TECHNICAL BULLETIN

Inoperative Blue Relay – Oxidized or Damaged Terminals – Checking/Replacement Guidelines

MODEL 1988-94 MY Sedan Range
XJS Range

86-178
Amended
8/97

ILLUSTRATION 1

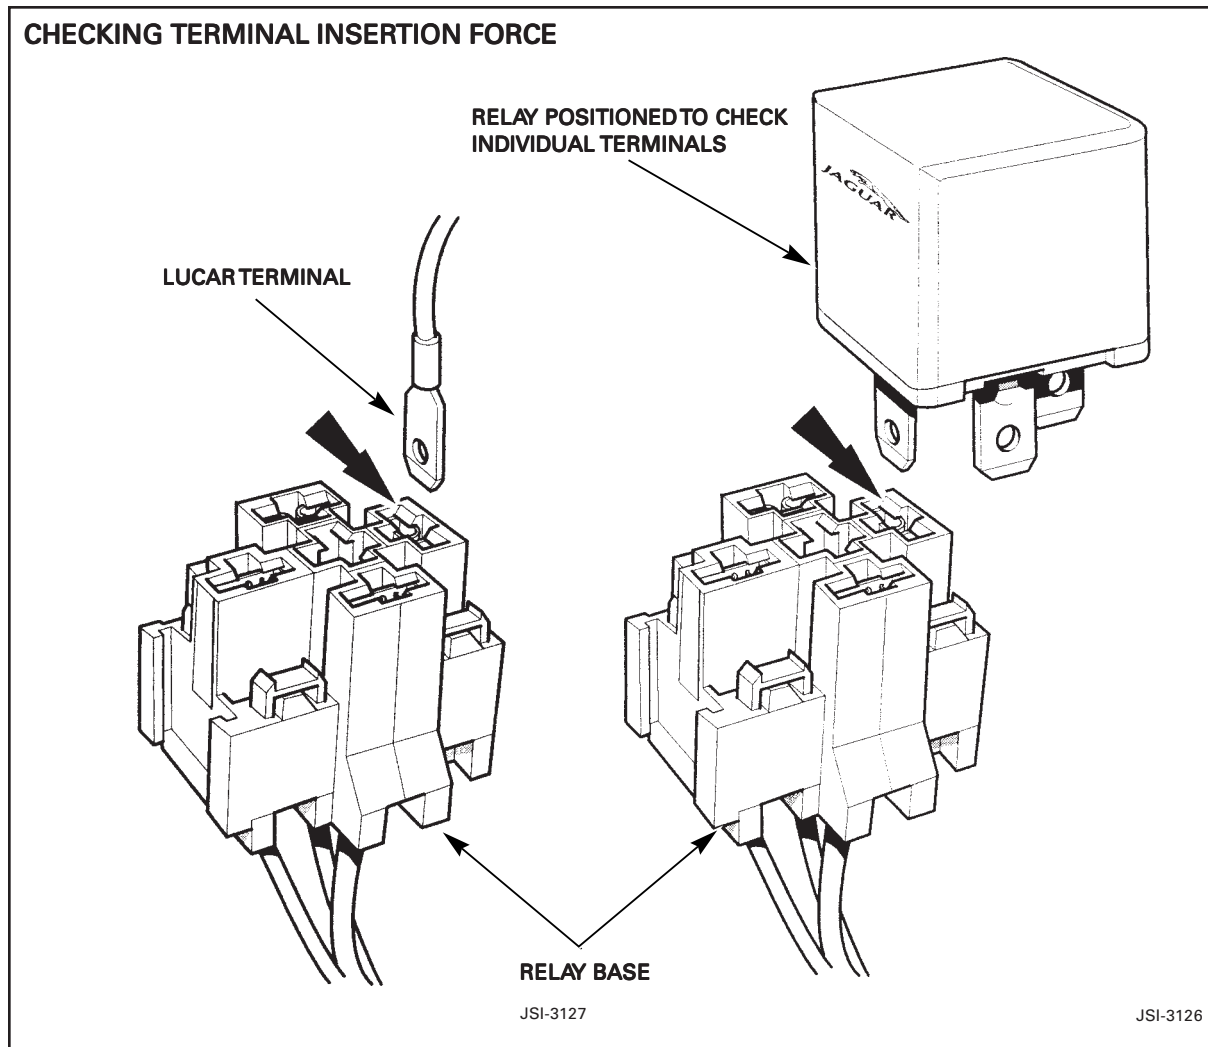
- If the relay still does not operate correctly, check the condition of the terminals in the relay's base. Check the force required to insert a terminal blade in each individual terminal of the relay base by using a spare 'Lucar' male terminal (Illustration 1) or by removing the relay and turning it so that one blade can be inserted into each terminal of the relay base, one at a time.

Tighten any loose terminals by pulling the terminal out of the relay base using the previously supplied Jaguar special tools (or equivalent such as Snap-On GA500A) and carefully closing the terminal with pliers to tighten the grip on the relay blade. Do not attempt to tighten the terminal while it is still in the relay base. Insert the terminal back into the relay base. Reinstall the relay and recheck its operation.

ILLUSTRATION 2

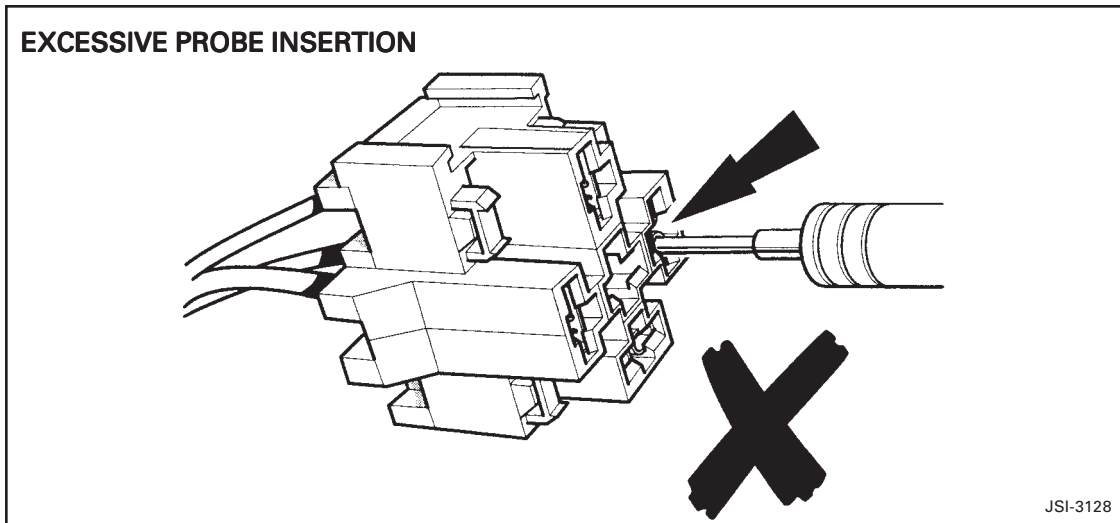
Loose terminals can be caused by forcing multimeter probes deep into the terminals (Illustration 2). To avoid this condition, lightly contact the terminals with the probes (Illustration 3).
